Buncombe County Planning Board April 15, 2013

SUB2013-00077

Brush Creek Subdivision applied for preliminary approval to site a major subdivision on the Northern side of Brush Creek Road in between the intersections of Upper Brush Creek Road and Witch Hazel Way (PIN 9685.32.5838).

Buncombe County Planning Board Meeting Recommended Staff Conditions **SUB2013-00077** April 15, 2013

USH CREEK SUBDIVISION

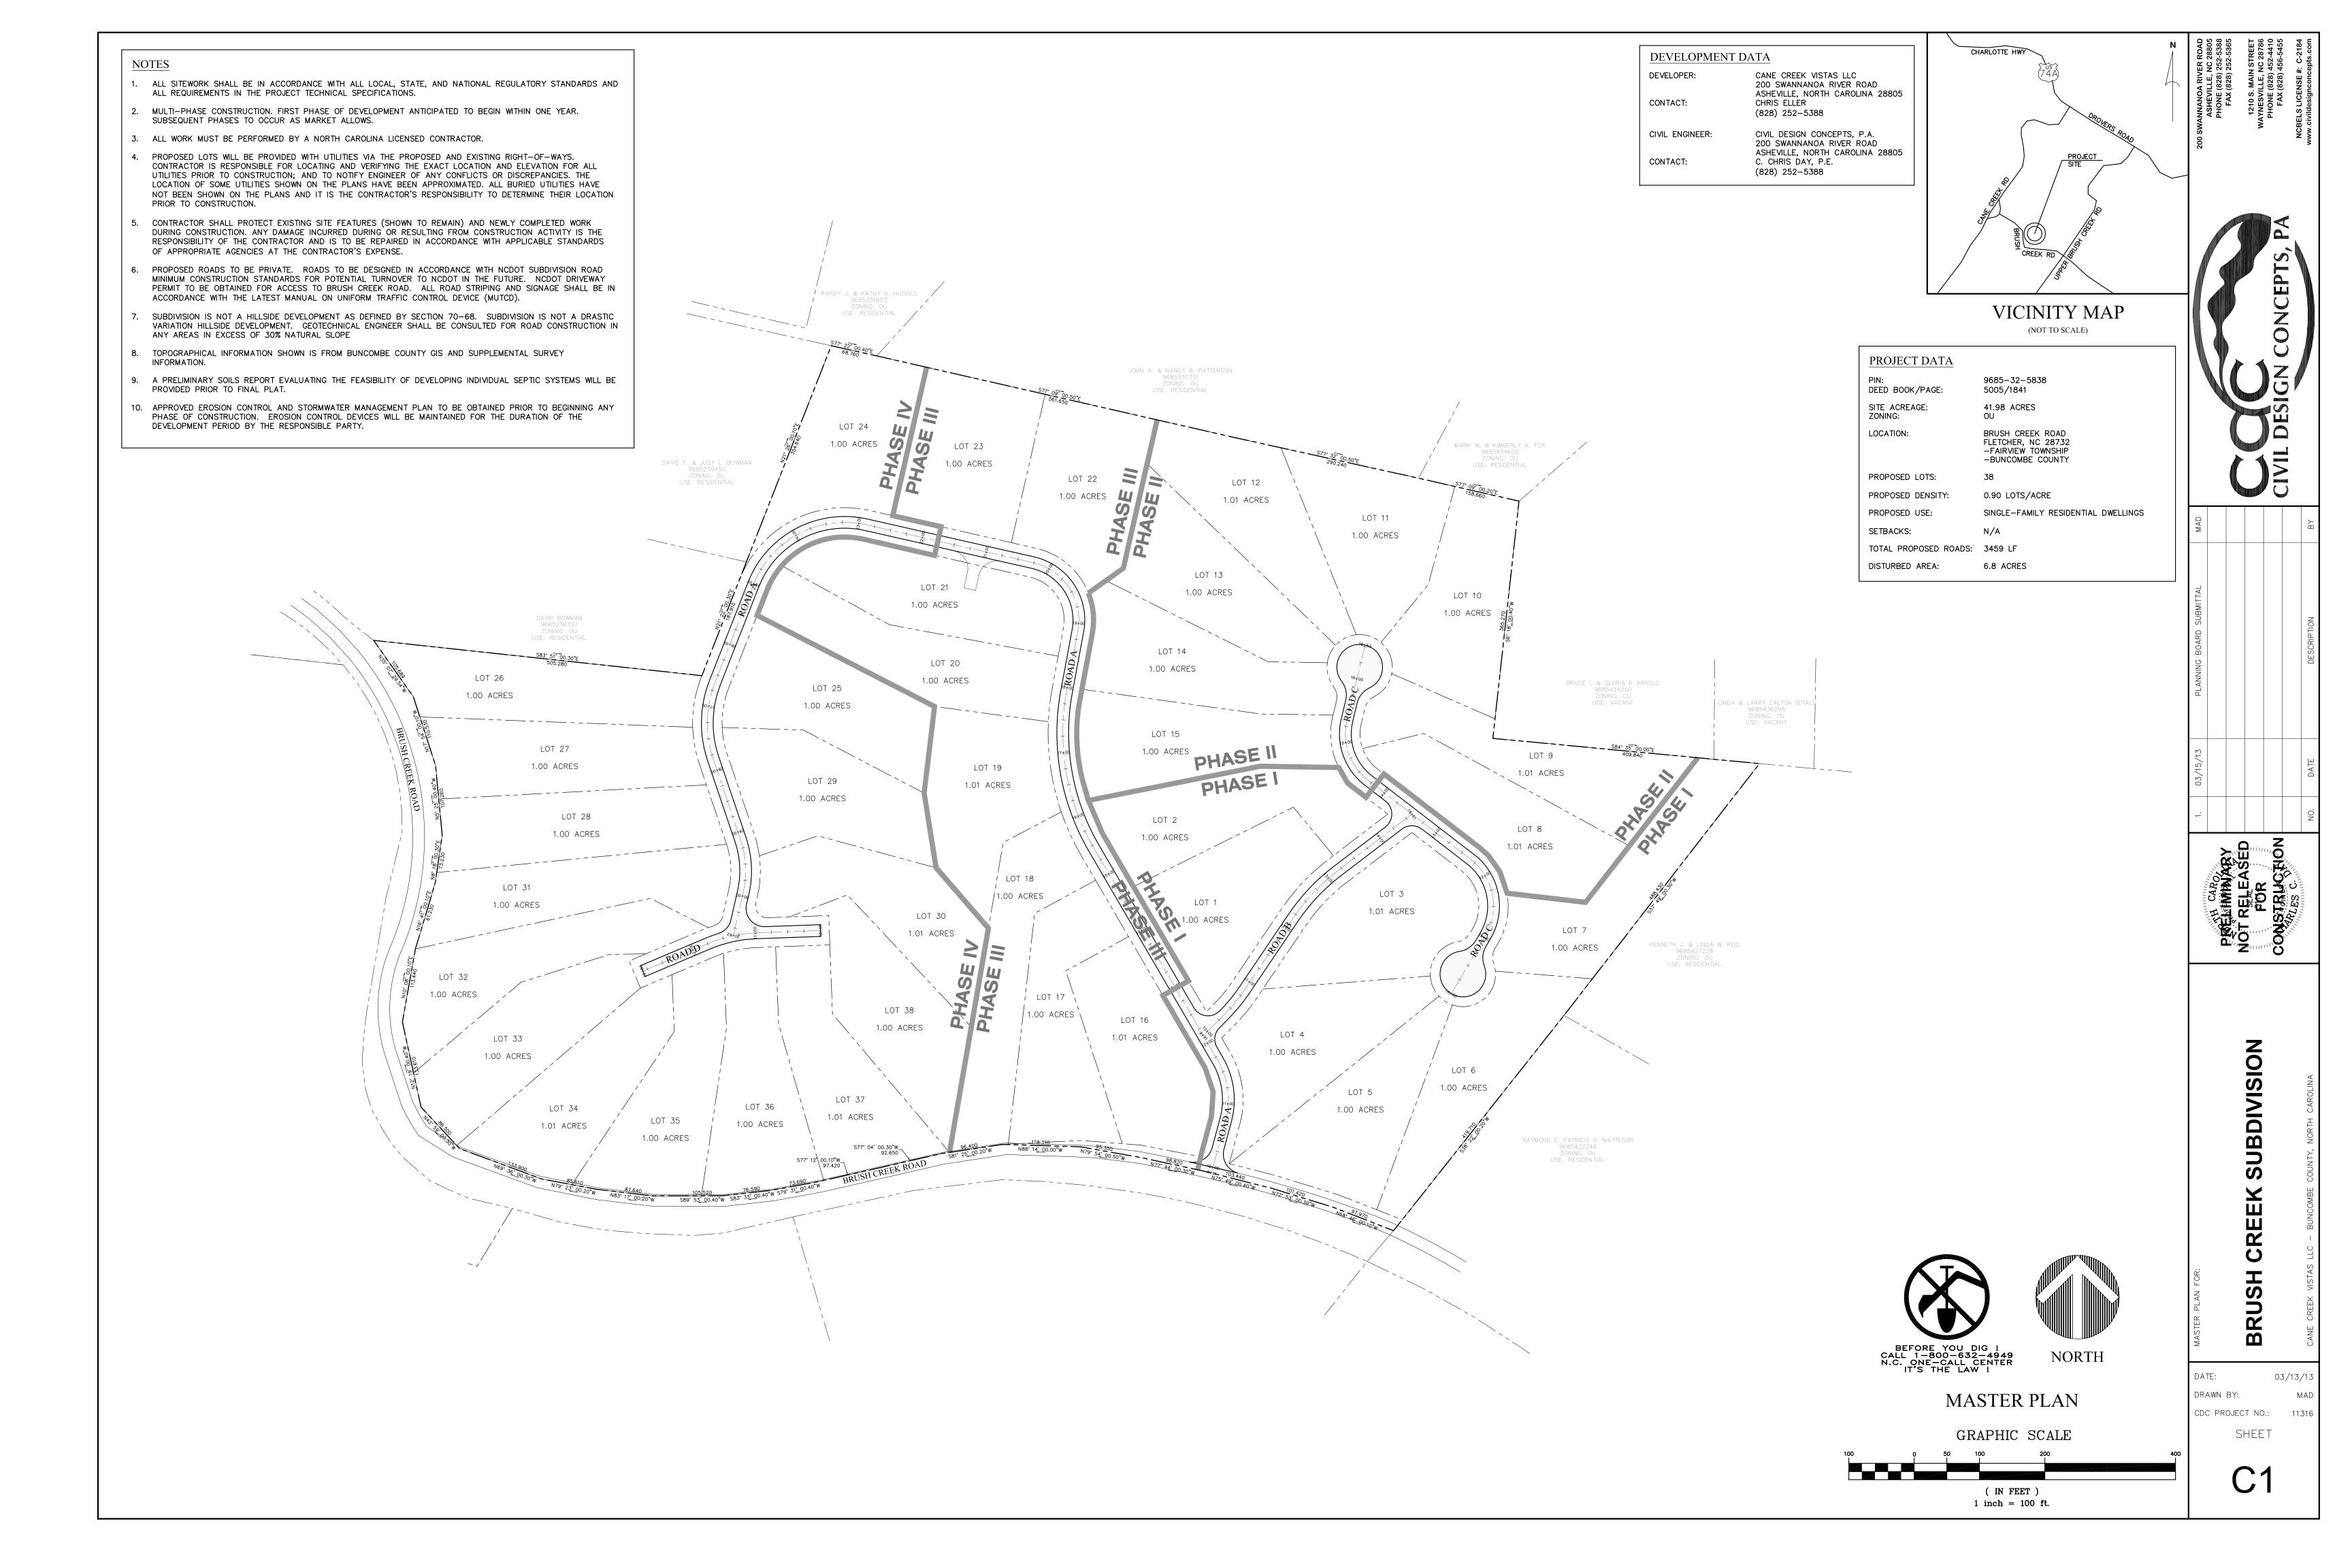
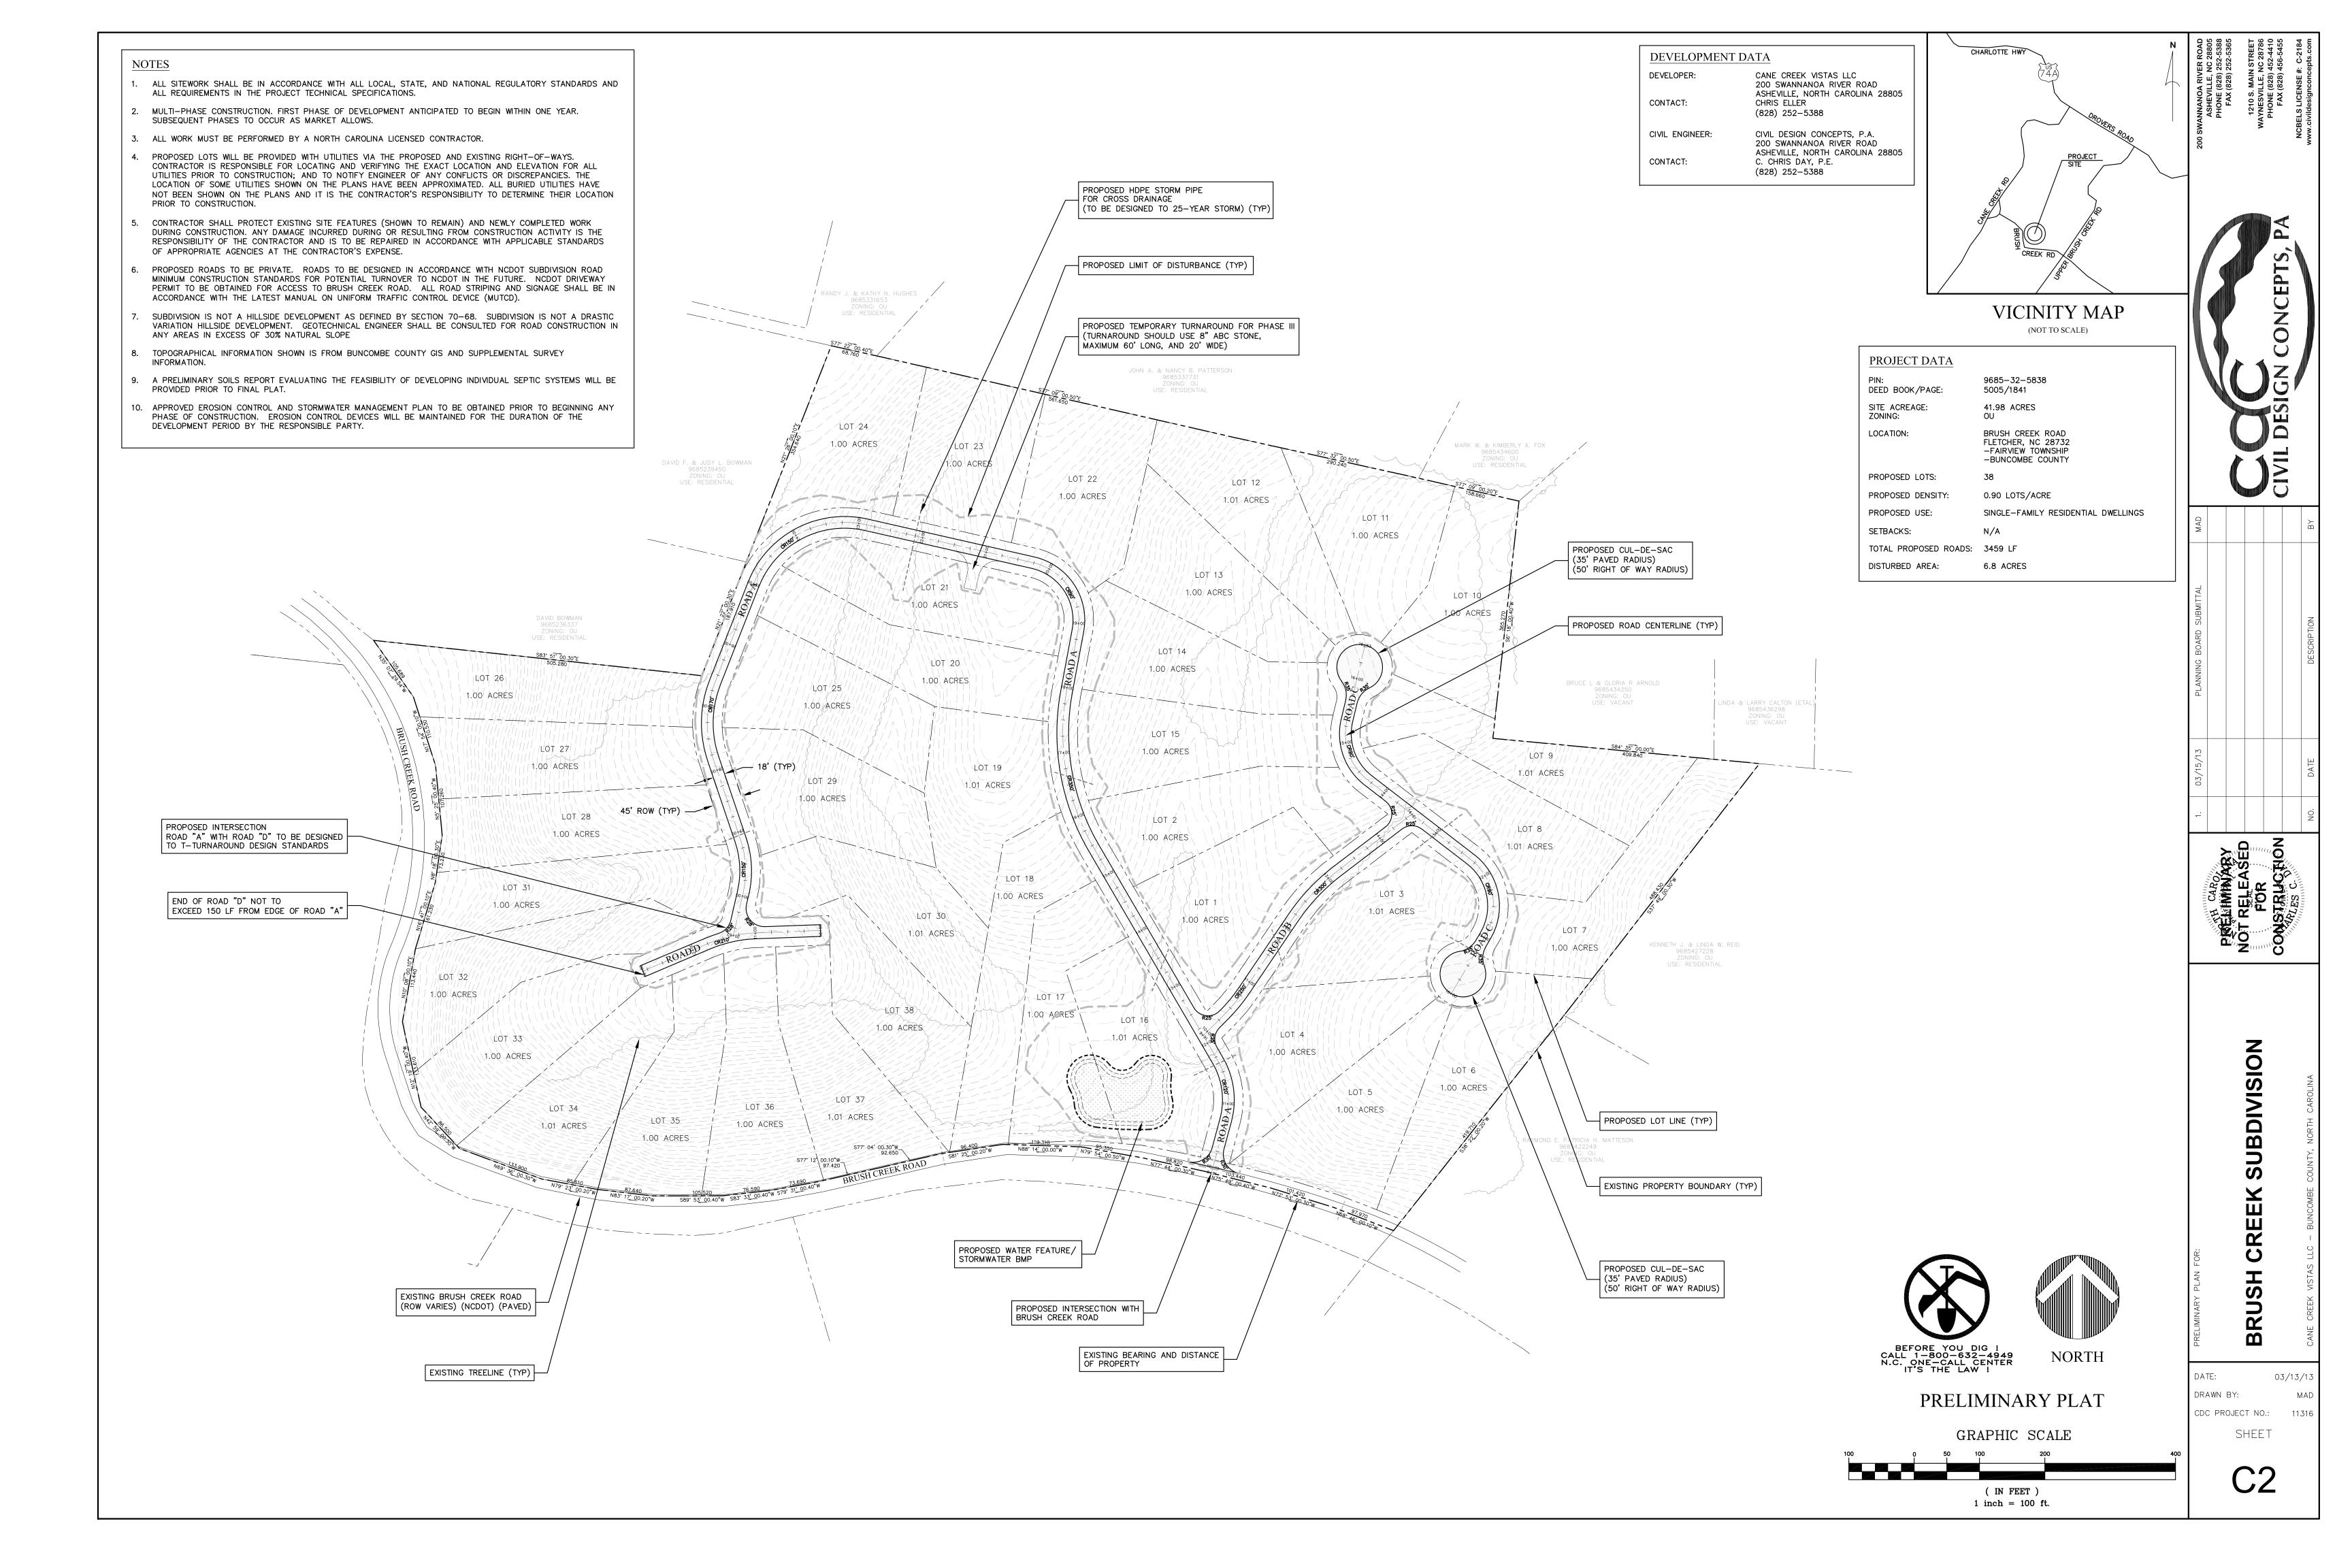
- 1. Indicate on the submitted plans that the lots will be served by septic and well.
- 2. Indicate the name of the owner on the submitted plans.
 3. Indicate the township the subdivision is located in on the submitted plans.

- 4. Indicate provision of the following on the submitted plans:
- a. Provisions for electrical and telephone services;
- b. Provisions for cable television service, if applicable;c. Provision of natural gas lines if applicable; and

- Or indicate that no provision for the items listed above has not been made.
- 5. Indicate contour interval on the submitted plans.
- 6. Indicate the existing use of the land within the subdivision.

- 7. Provide a copy of the approved North Carolina Department of Transportation driveway permit.
- 8. Provide proof of approval of road names and addresses from E-911 Addressing.

- 9. Provide curve data for proposed roads.
- 10. Indicate on the submitted plans that no base course shall be placed on muck, pipe clay, organic matter or other unsuitable matter, and a minimum compaction rate of subgrade prior to paving shall not be less than 95 percent by standard proctor method.

- 11. Provide information on the submitted plans that the subdivision roads meet the following standard: they are contained within a corridor that shall not exceed 90 feet in width along 80% of its total length; up to 20% of the length of the road corridor may be graded to a maximum width of 135 feet. The corridor height, defined as the height of a combined cut and fill slope, shall not exceed 60 feet.

- 12. Indicate areas of road construction in excess of 30 percent natural slope or areas designated as High Hazard or Moderate Hazard on the Buncombe County Slope Stability Index Map or indicate on the submitted plans that no such areas exist.

- 13. Indicate location of individual driveways for the first 20 feet for each lot on the submitted plans.
- 14. Subdivision roads shall be paved in accordance with NCDOT "Subdivision Road Minimum Construction Standards," Pavement Design 1(E), current edition. Specify soil conditions and which combination of base and pavement design (see DOT guidance) will be used. Use worst-case design criteria if soil testing is not

- 15. Proof of preliminary soils investigation that will evaluate the feasibility of developing a subdivision served by individual septic systems, which shall be done by a professional such as a soils engineer or soils scientist

- 16. Provide a written statement from the Buncombe County Erosion Control Officer stating that an Erosion Control Plan has been submitted and approved for the project. No grading shall occur on the site until an approved Buncombe County Erosion Control permit is obtained.

- 17. Provide a written statement from the Buncombe County Stormwater Administrator stating that a stormwater management plan has been submitted and approved for the project. No grading shall occur on the site until an approved Buncombe County Stormwater Permit is obtained.
